SUBJECT: **Invitation for Bid # 10-0642-DS**
Oneco Terrace, Sunniland and Kirk Haven Water Phase 2
(Project No. 6025570 6.2)

ADDENDUM # 3

Subject: Responses to Pre-Bid and Bid Questions for Oneco Terrace Phase II

ONECO TERRACE WATERLINE REPLACEMENT (PHASE II)

MANATEE COUNTY TRANSPORTATION DEPARTMENT		CURB & GUTTER CONTROL SHEET	201.0
REV. BY	DATE		
	6/12/07		
	DATE OF B.O.C.C. APPROVAL

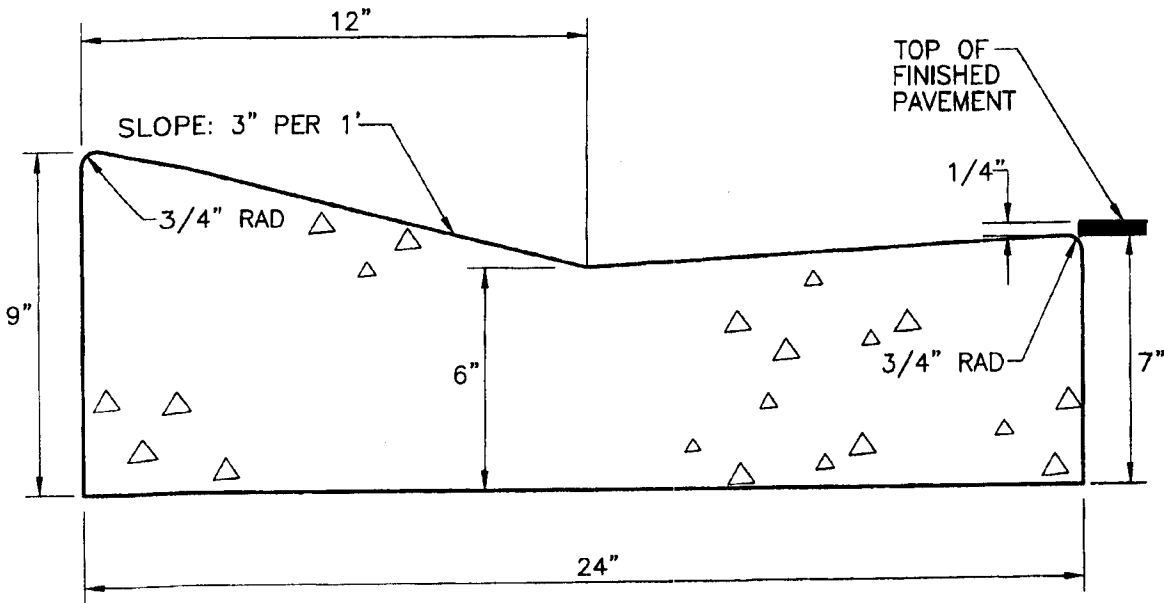
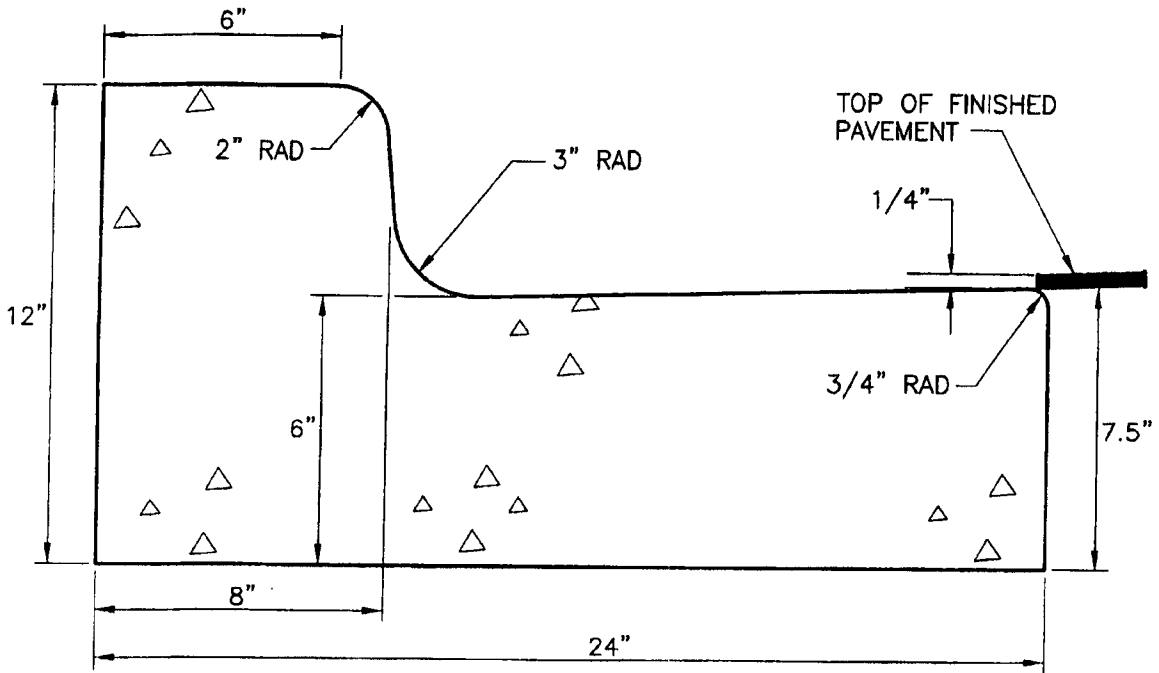
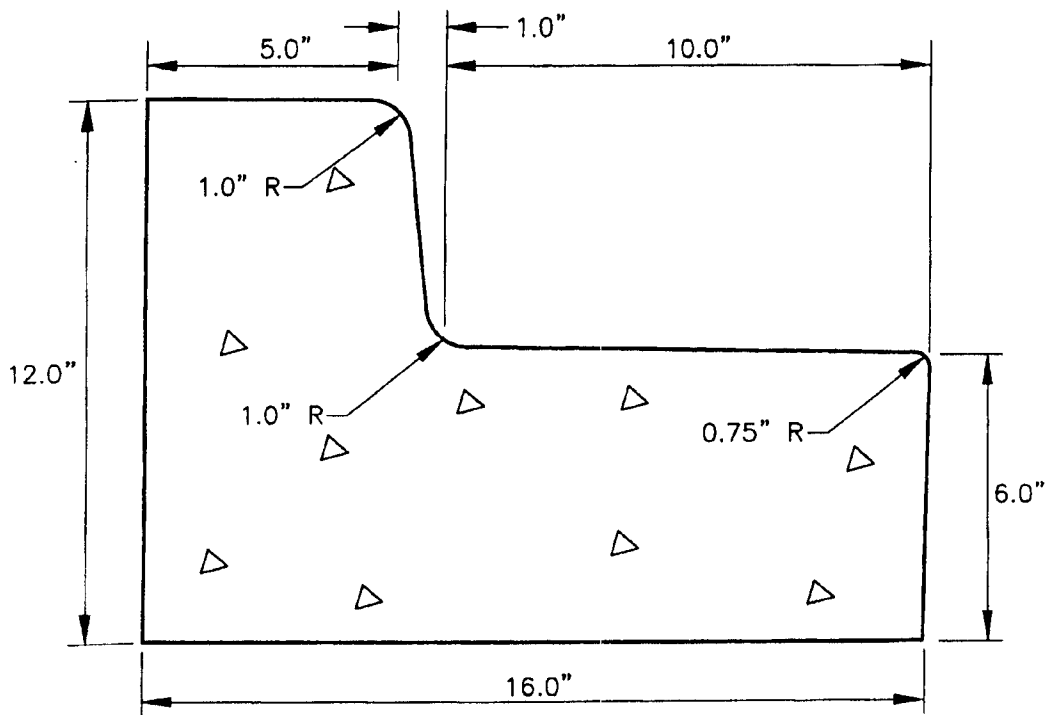
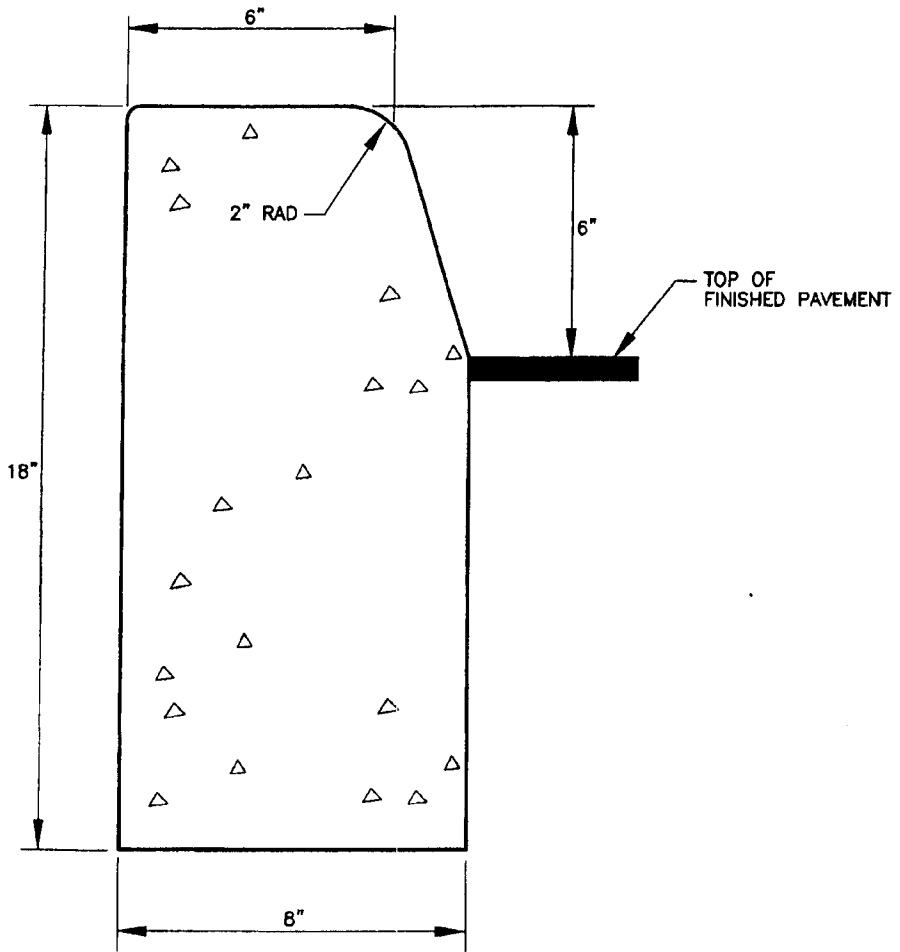
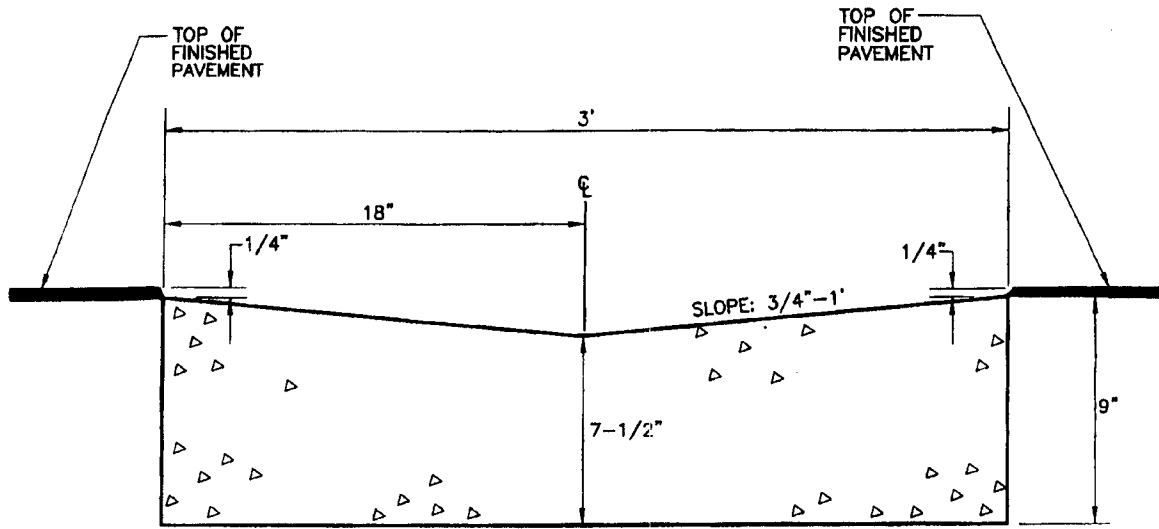
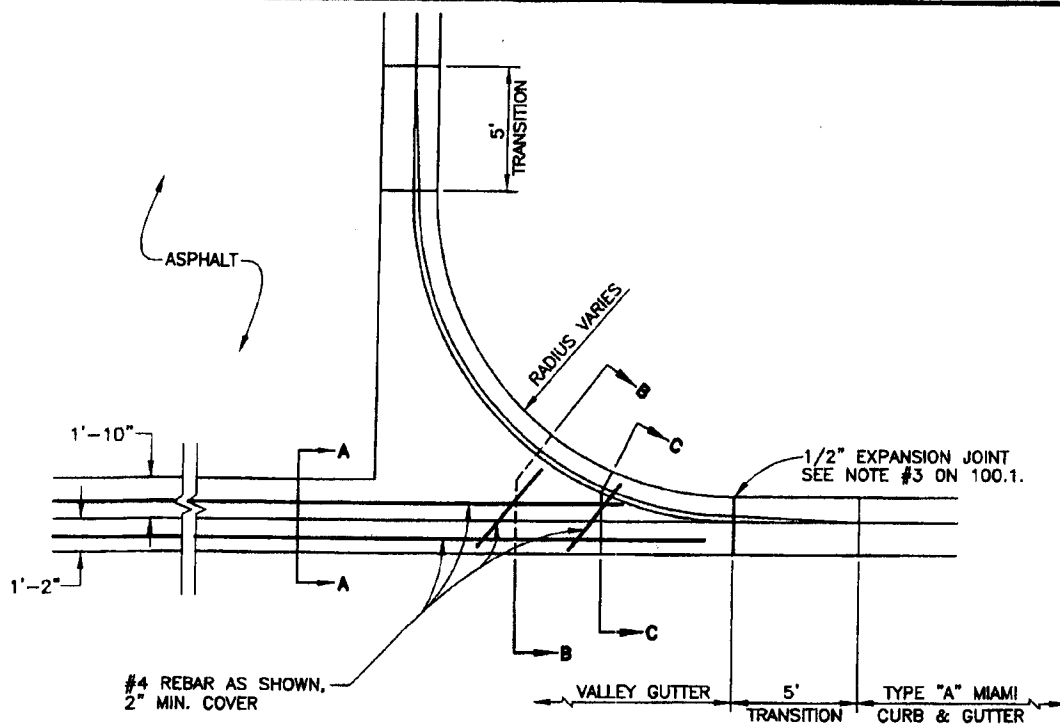
12. In several areas, curb and gutter will need to be replaced after water line is installed. Will there be consideration given in adding a pay item (similar to concrete driveway and asphalt pavement replacement) to account for this item? Additionally, please include a specification detail for curb replacement.

Separate pay item have been added for curb and gutter replacement. Curb and gutter shall meet the specifications and details established by Manatee County Transportation Department Highway, Traffic & Stormwater Standards, 2007 edition and FDOT standard Roadway and Traffic Design Standards Index No. 300, latest revision. Applicable Manatee

County Standards are attached, bidders can obtain FDOT standards from the FDOT website.

JOB NO. 7880D.10
 DRAWING NO. P-04
 SHEET NO. 4 OF 14

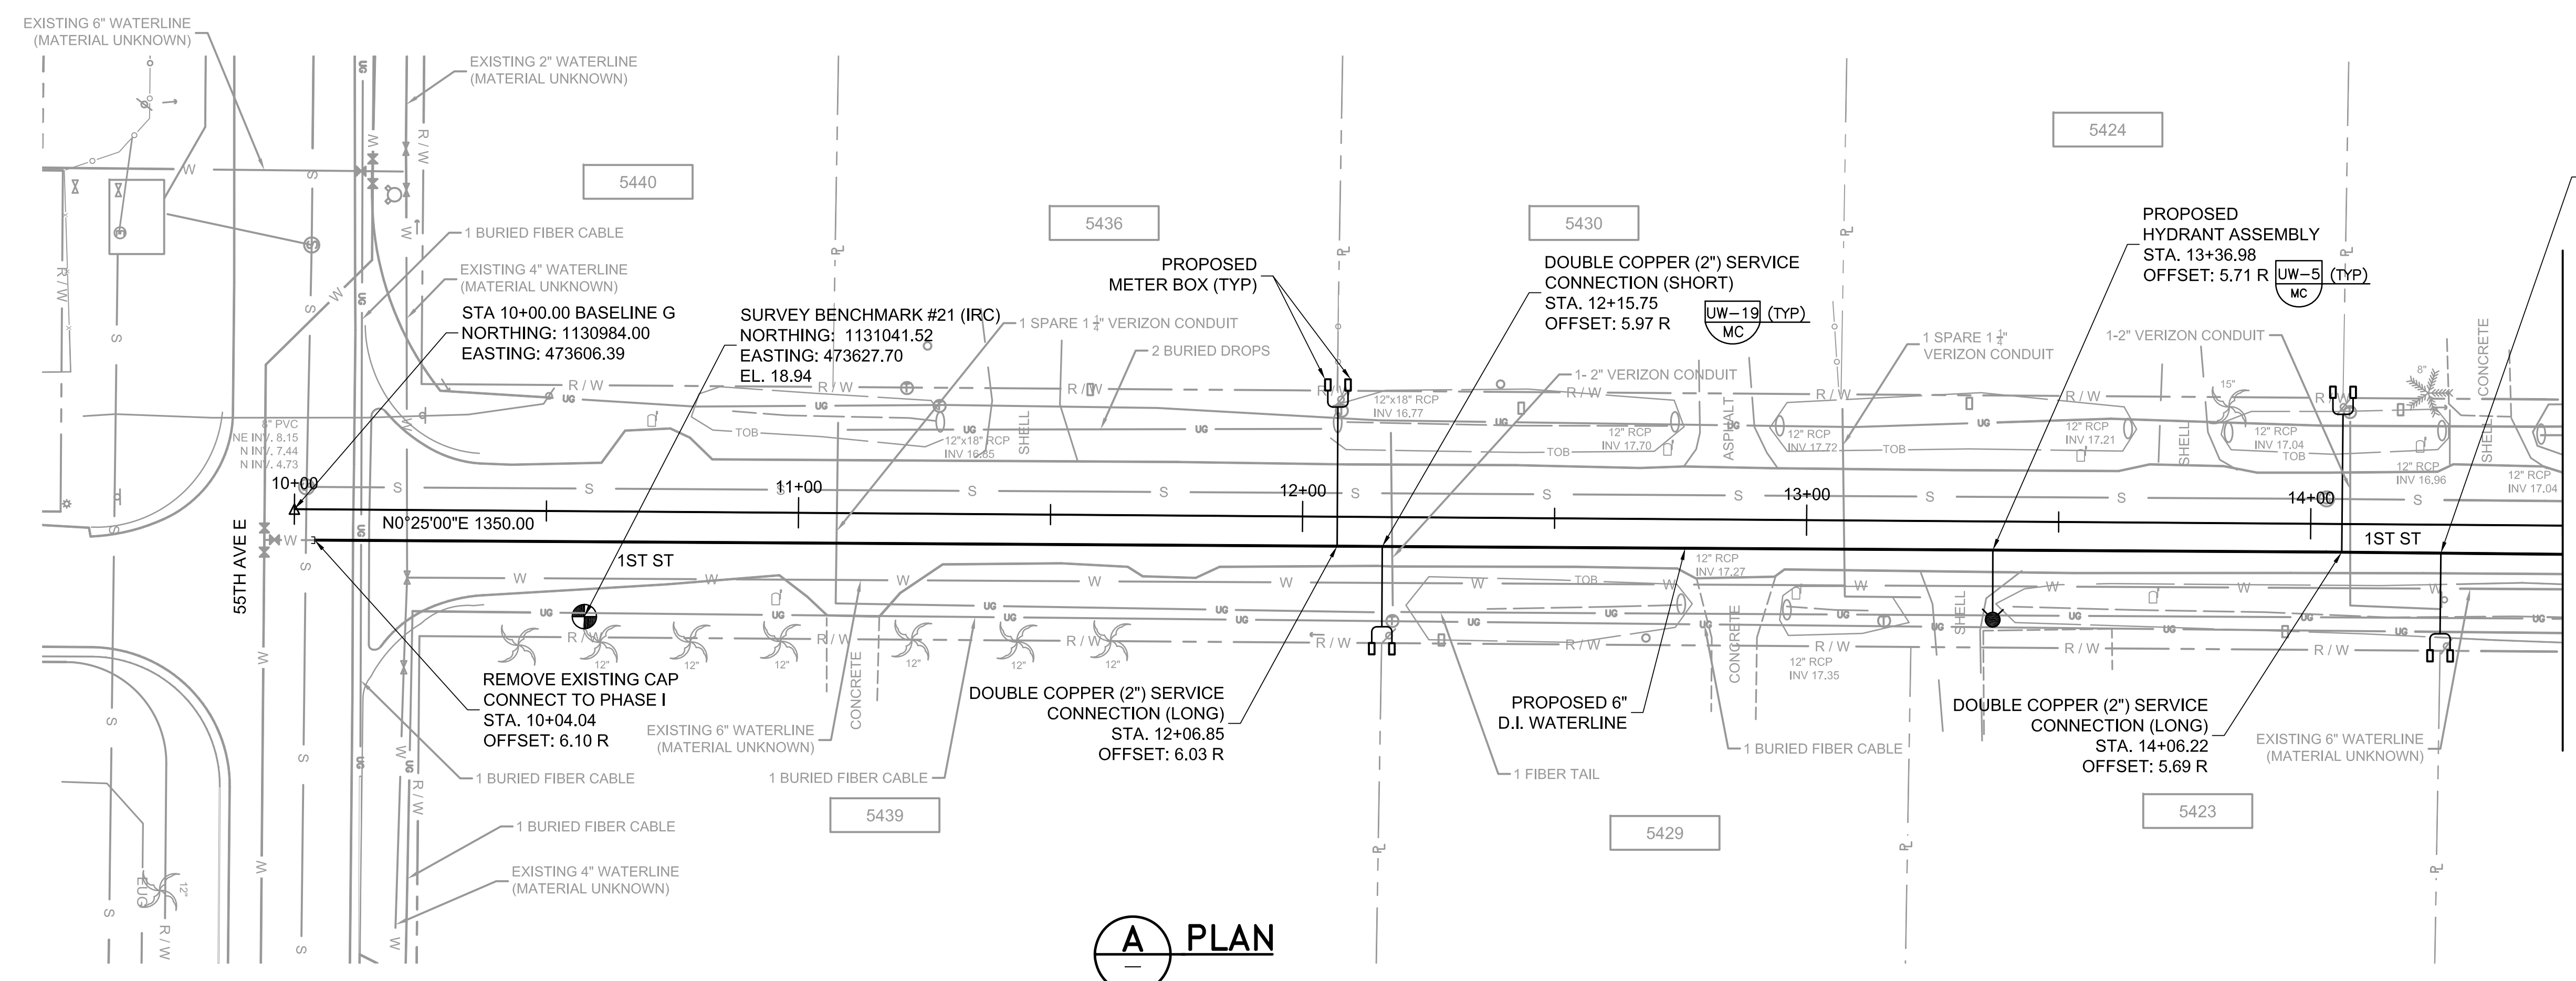
2. Sheets 4, 8, 9, 10, 11 of the plan set show Double PE services (short). There is no pay item for this service connection.

3. Sheets 4 and 9 of the plan set show Single PE services (long). There is no pay item for this service connection.

A bid item has been added for short side double PE services and quantities have been adjusted accordingly on the Bid Form.

A bid item has been added for long side single PE services and quantities have been adjusted accordingly on the Bid Form.
